ADDENDUM NO. 2

To: Invited Bidders
Project: **St. Mary Fort Walton Beach Admin Building & Renovation**
Fort Walton Beach, Florida
Date: May 19, 2026
Architect: Quina Grundhoefer Architects

Date: 04-24-26
Project No. 2025
Sheet No. **E0.1**

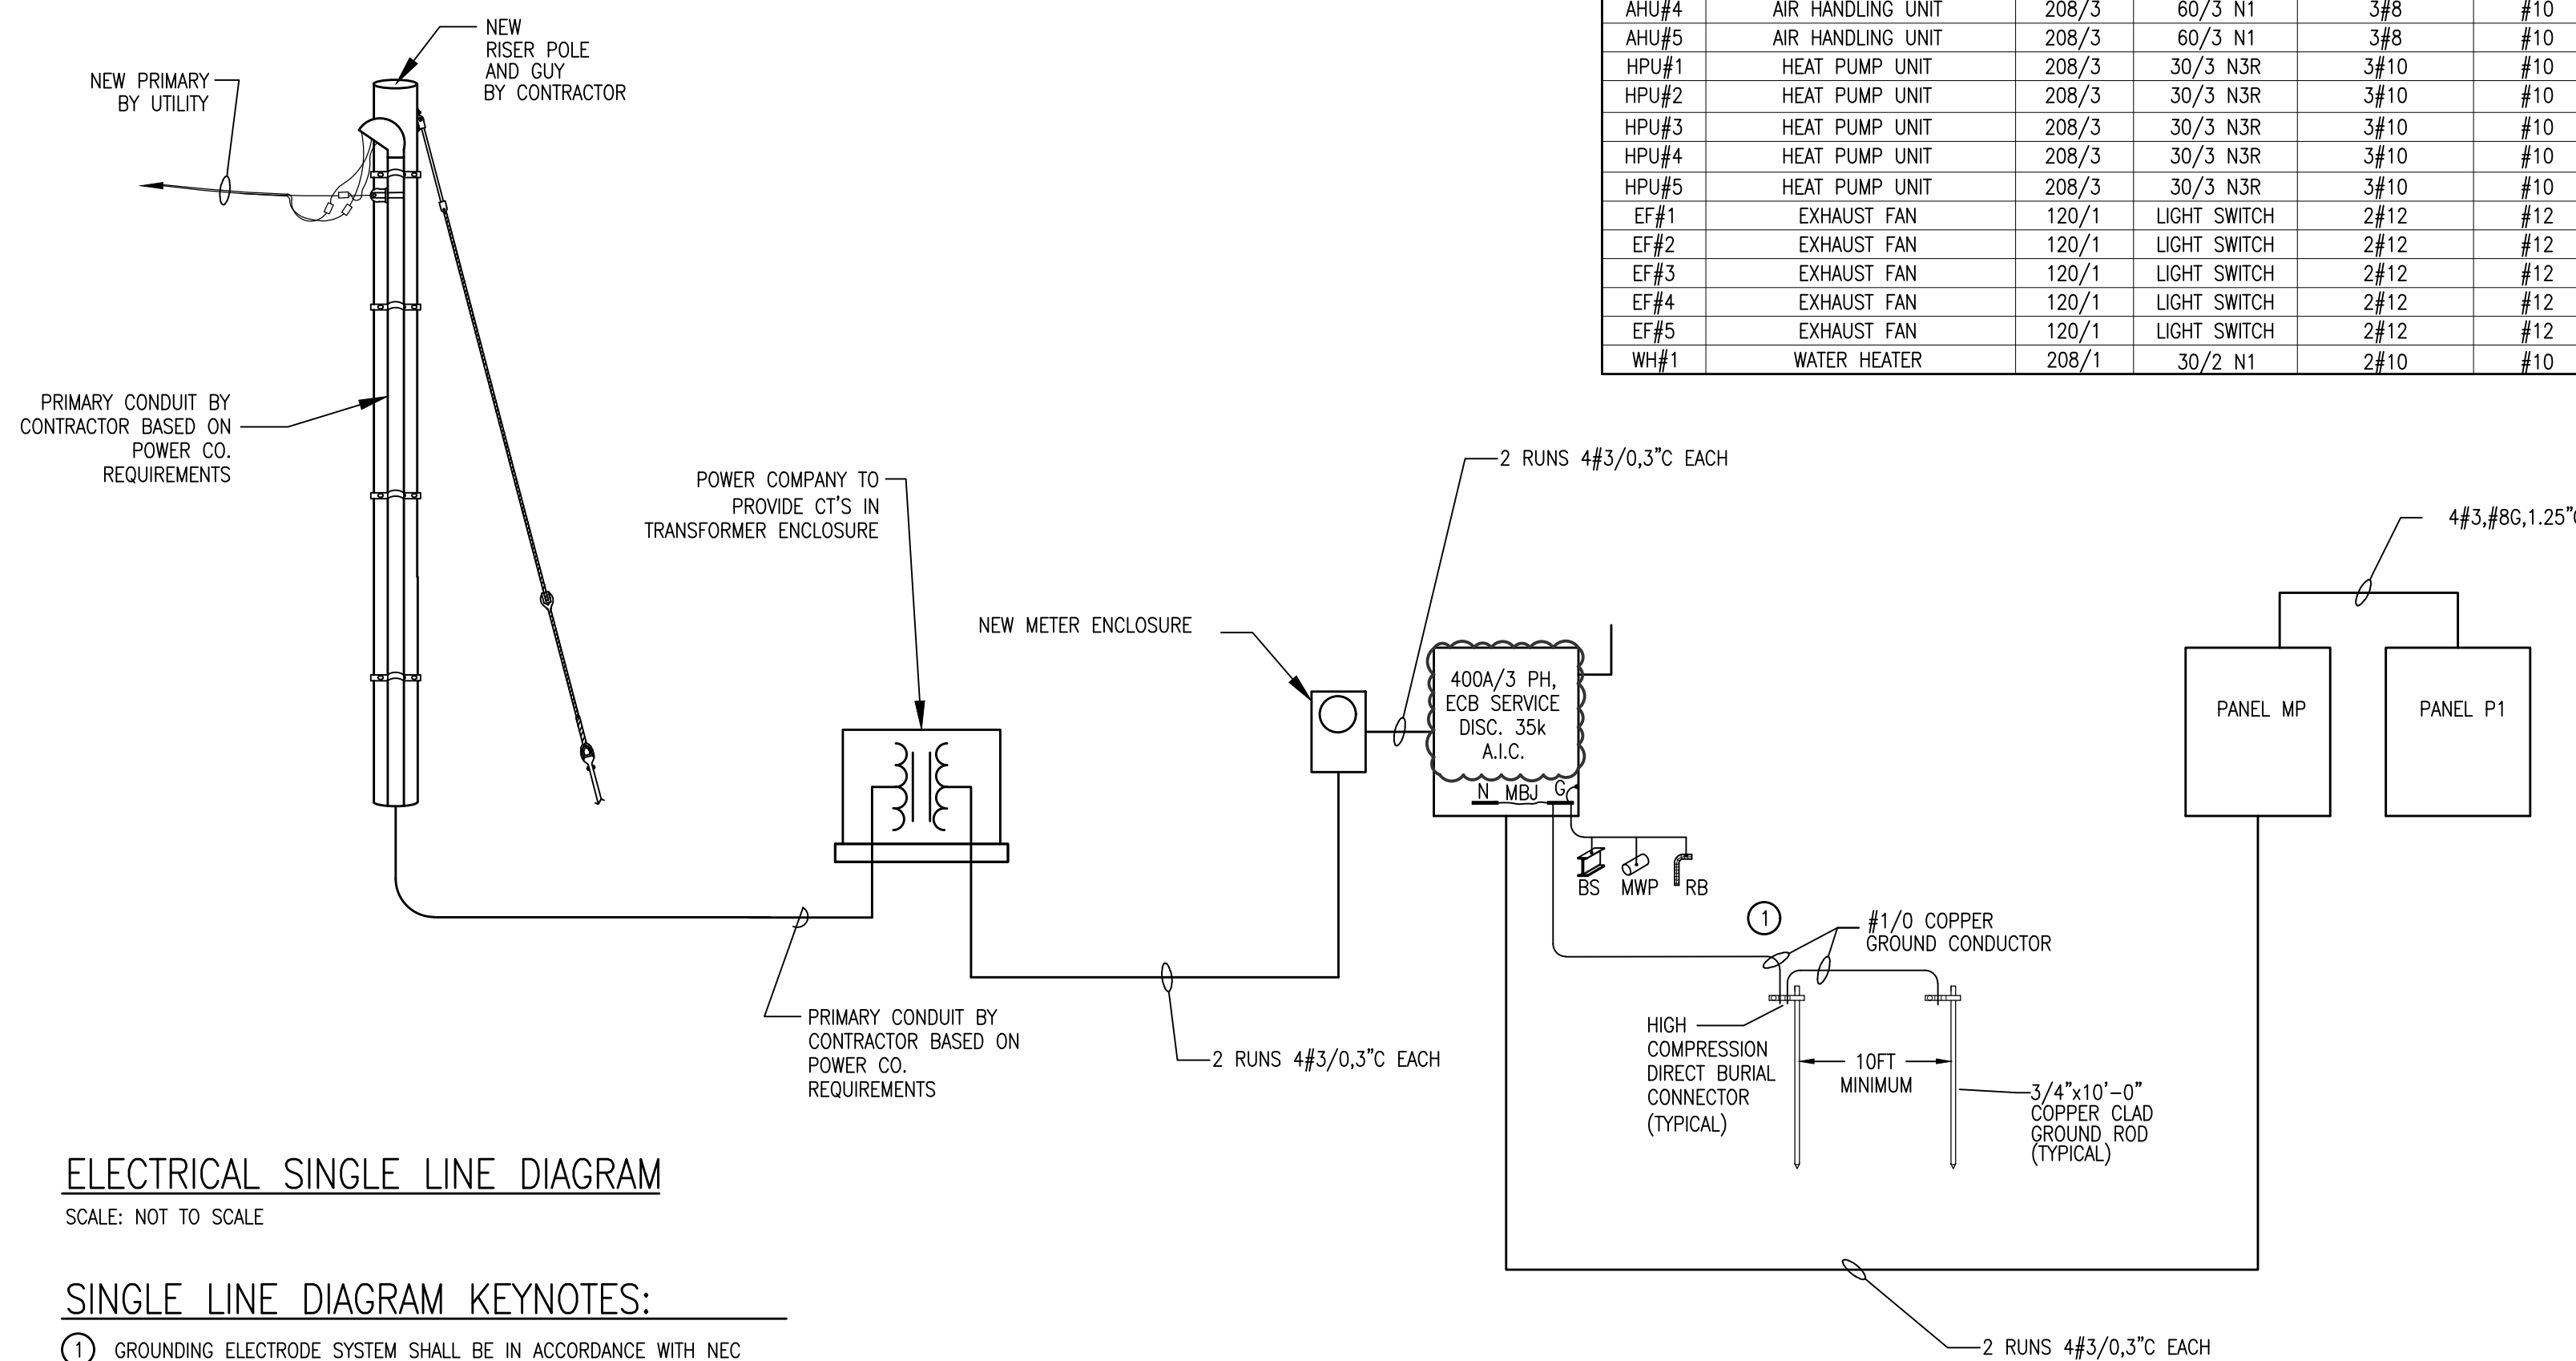
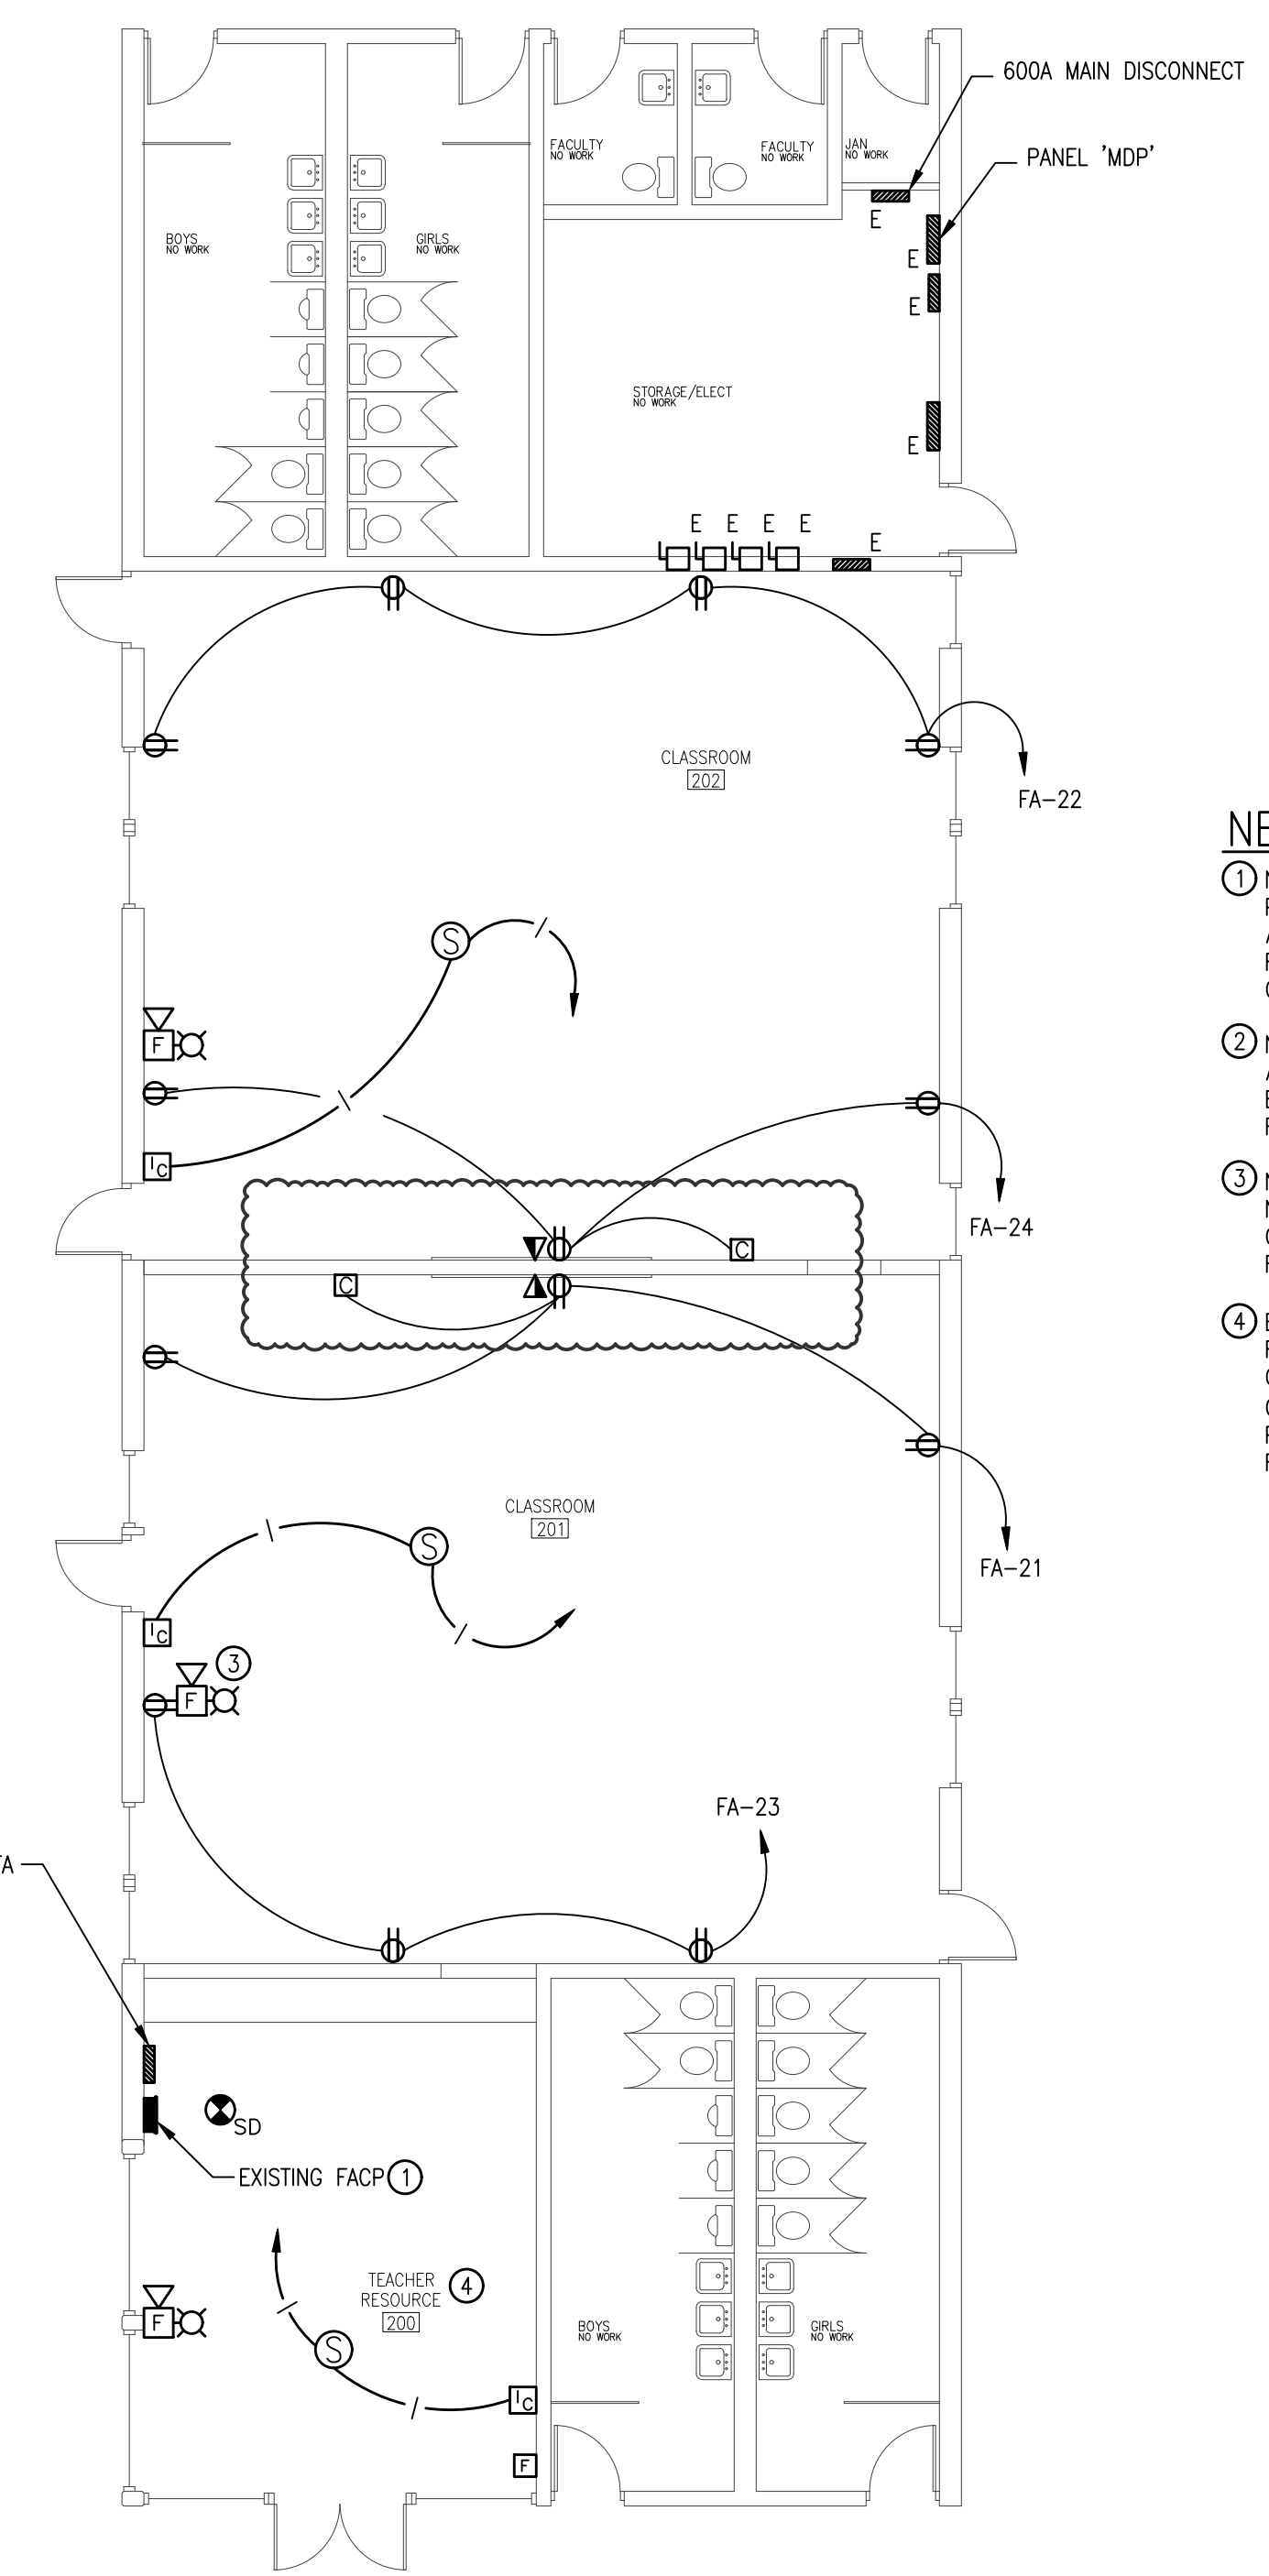
1. **Refer to Attached Revised Sheet E0.1:**
 - a. Changed A.I.C. rating to 35,000 amps in the panel schedules.
 - b. Added the E.C.B. A.I.C. rating to the riser diagram.
 - c. Added a circuit to the panel schedule for a surge protection device required at the main panel.
2. **Refer to Attached Revised Sheet E2.2:**
 - a. Revised drawing to show wall clocks powered by 120V receptacle circuits.
3. **Clarification to Sheet E2.2:**
 - a. Owner to provide wall clocks.
